COMMITTEE OF THE WHOLE MARCH 7, 2005

**SITE DEVELOPMENT FILE DA.04.019
995245 ONTARIO LIMITED**

Site Plan

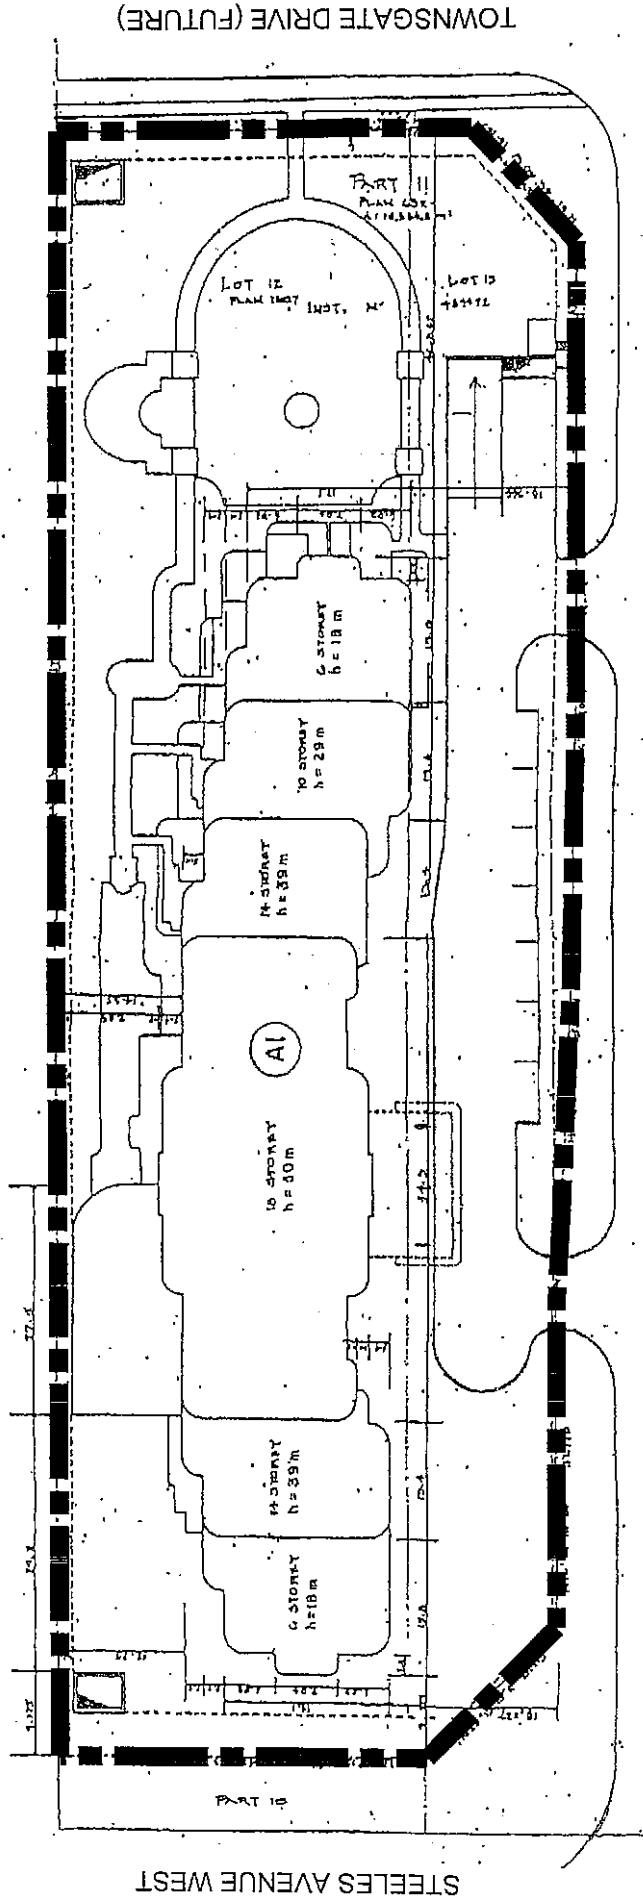
The proposed site plan is shown on Attachment #2. The rectangular-shaped property is to be developed with one 12-storey building located towards the south end of the site, with access from two 7.5m wide driveways on Palm Gate Drive, which will be constructed concurrently with the site development. Minimal parking is provided on the ground level with the majority being in the two-level underground garage (with entry on the north side of the building). A loading area is located on the west side of the property.

Pedestrian circulation throughout the site will be facilitated by an internal walkway system through the large amenity landscaped areas around the site, leading to resident entry points around the building. A connection is provided to the daylight triangle at the southeast corner of the property for pedestrian access to and from Steeles Avenue and Palm Gate Drive. Sufficient landscaped buffers are provided adjacent to the lot lines, including the 25m wide landscaped berm adjacent to the north property line.

Landscape Plan

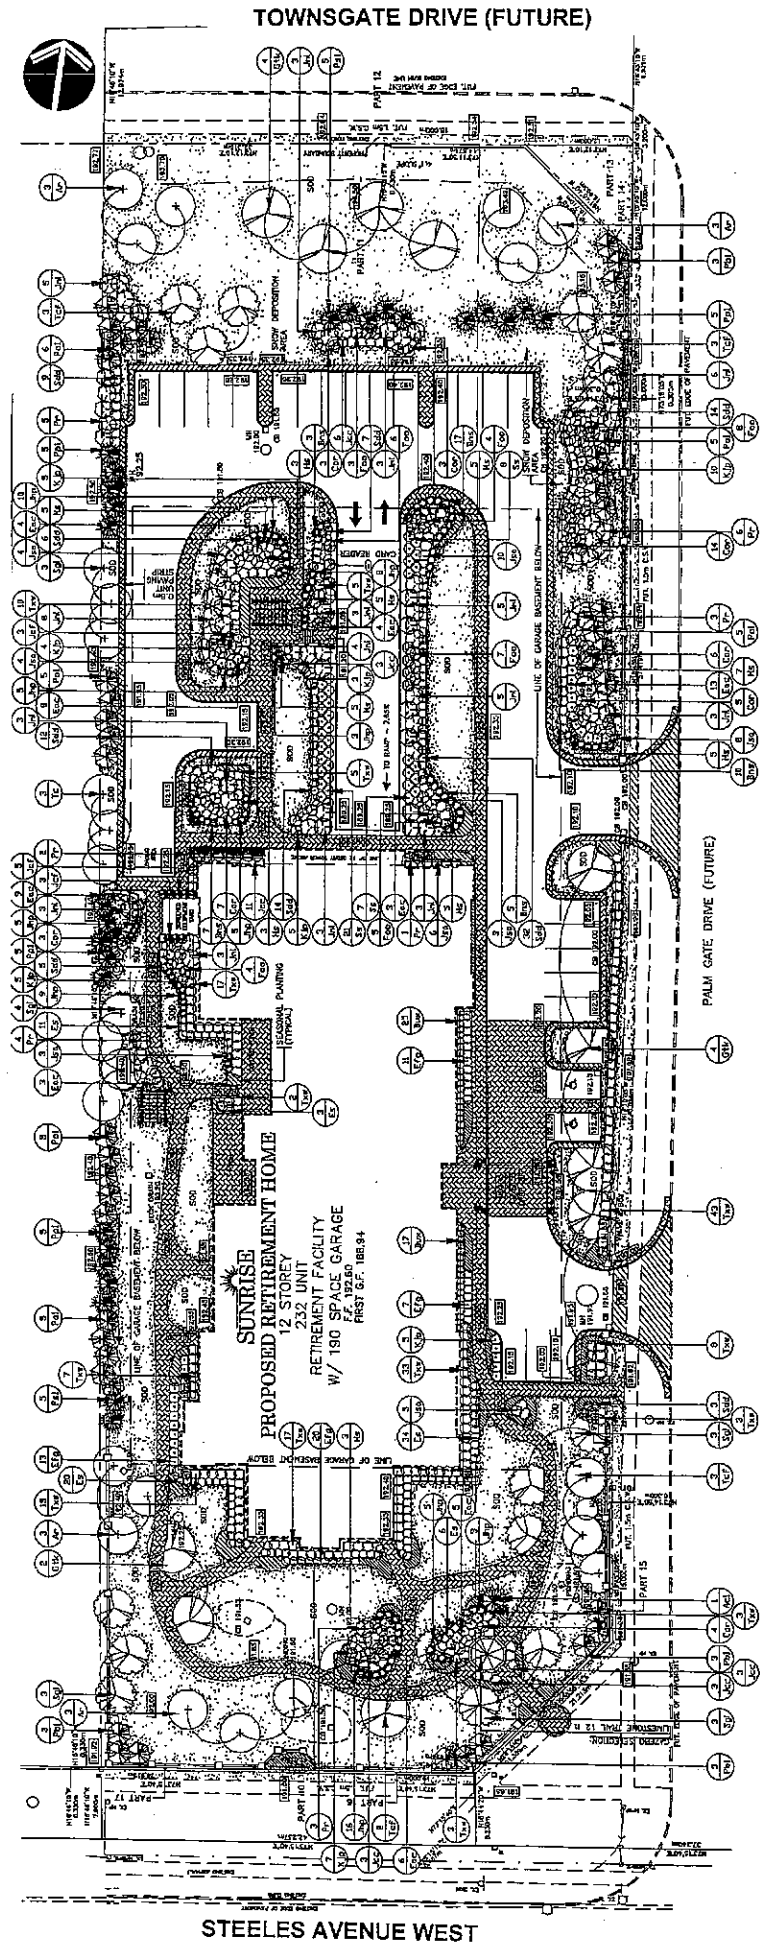
The site will be landscaped (Attachment #4) with a mix of deciduous and coniferous trees and shrubs, along all property lines. A 25m wide landscaped buffer is located along the northerly property line (future extension of Townsgate Drive), in accordance with the policies in OPA #247. This landscaping will screen the underground garage ramp and parking areas. The area in front of the main entrance to the building will be treated with concrete pavers.

By-law 1-88 requires a 3.0m wide landscape strip to be provided around the periphery of an outdoor parking, and to consist of an earth berm or evergreen hedgerow with a minimum height of 1.2m. Given the large amount of landscape on site, Staff is satisfied that a 3.0m wide landscape buffer can be provided in all areas except beside the parking adjacent to Palm Gate Drive where a 1.42m wide buffer is proposed with a mix of species and heights.

The final landscape plan will be approved to match the site plan design on Attachment #2, to the satisfaction of the Development Planning Department.

Elevation Plan

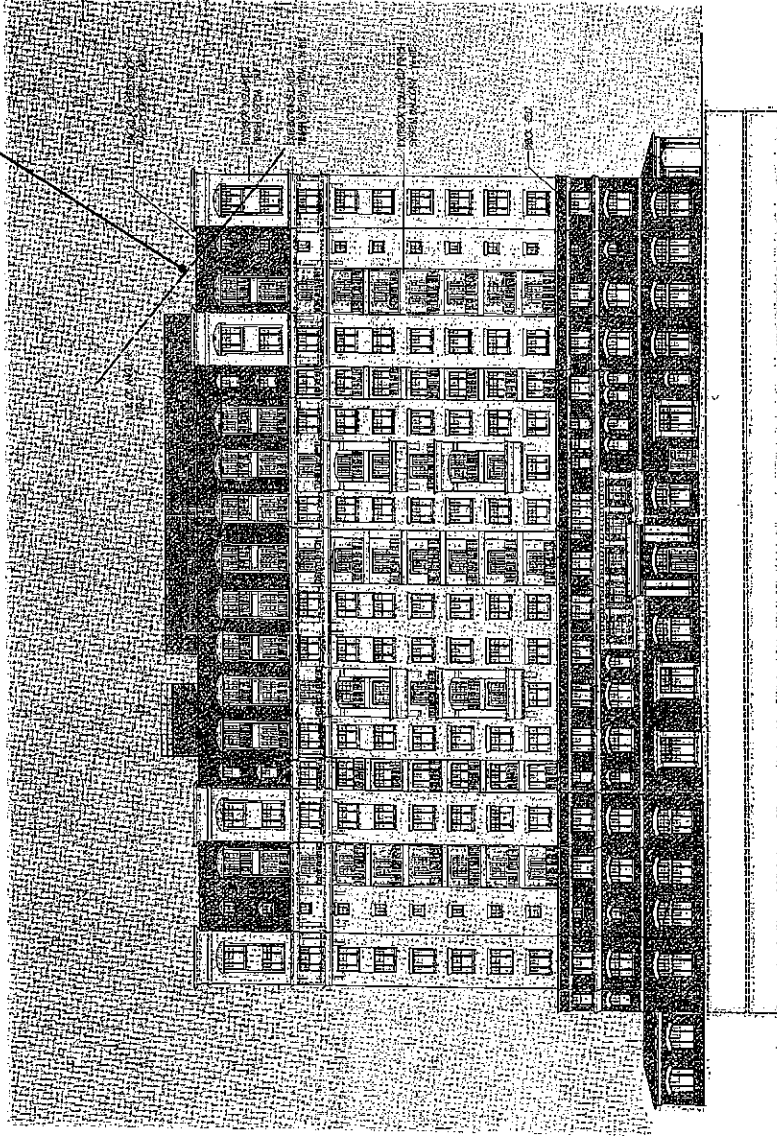
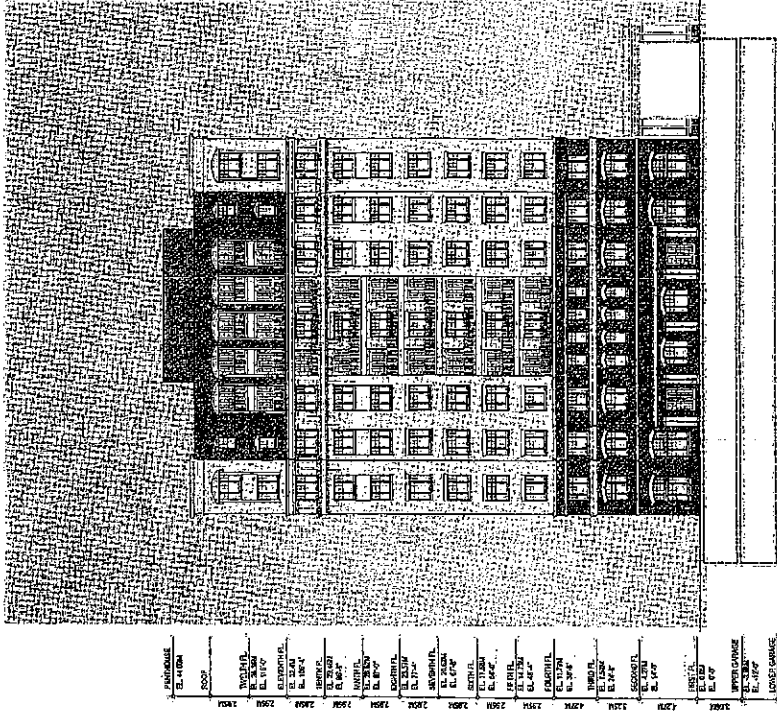
The intent of the substantial landscape buffer and the angular visual plane was to ensure the appropriate integration of the high density residential with the northerly low density development. As only a small amount of the northerly portion of the building extends above the angular visual plane as shown on Attachment #5 and #6, Staff is satisfied that the intent of OPA #247 has been met.

The 12-storey, 30,299m², irregular-shaped building is proposed to a maximum height of 44m, and is shown on Attachment #5 and #6. This height is lower than the previously approved 1989 site plan, which proposed maximum of 18-storeys on 50m building height. All roof-top mechanical equipment will be screened from street view. The main entrance is on the east façade and faces Palm Gate Drive. A covered pick-up and drop off area extends over the main driveway in front of the building. The lower portion (floors 1-3) of the building consists of red brick material. The main material on floors 4-10 is an exterior insulated finish system in for each unit in a buff colour. The remaining material for the upper portion (floors 11-12 and roof) consists of aged-copper (green) metal siding. Clear-glazed windows are evenly spaced along the facades for each unit. In addition, white-coloured balconies and trim and evenly spaced along the east and west facades and centrally located on the north and south elevations.

Elevation Plan

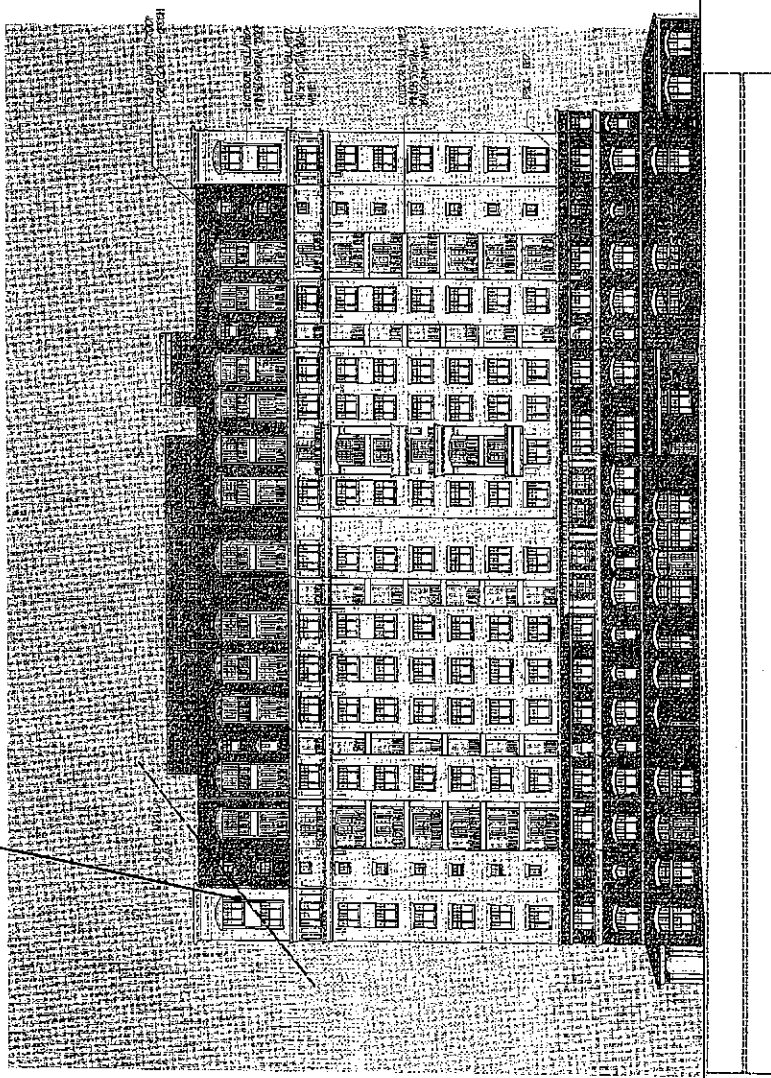
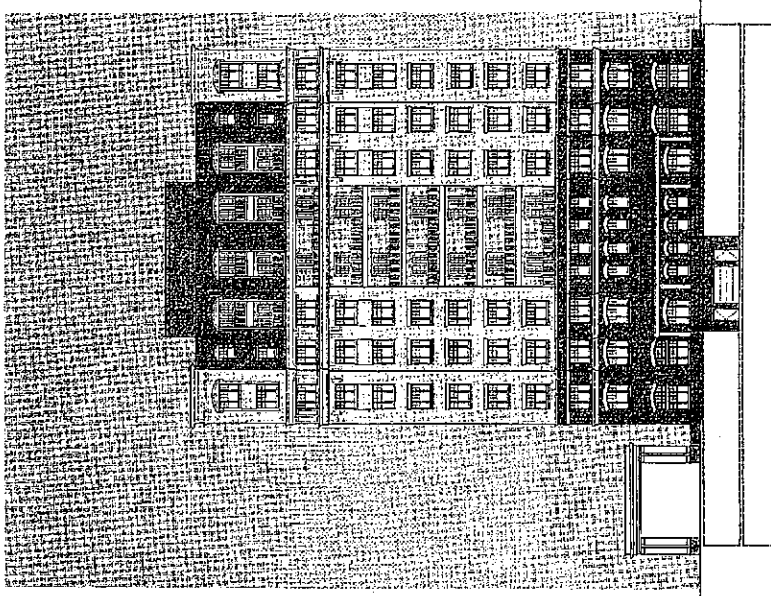
The remaining north and south facades are consistent in colour and material, with the additional elements of the underground garage entrance on the north façade, and 2 main double-entry doors on the south and west façades. In addition, the west elevation has 2 man-doors and a covered porch area.
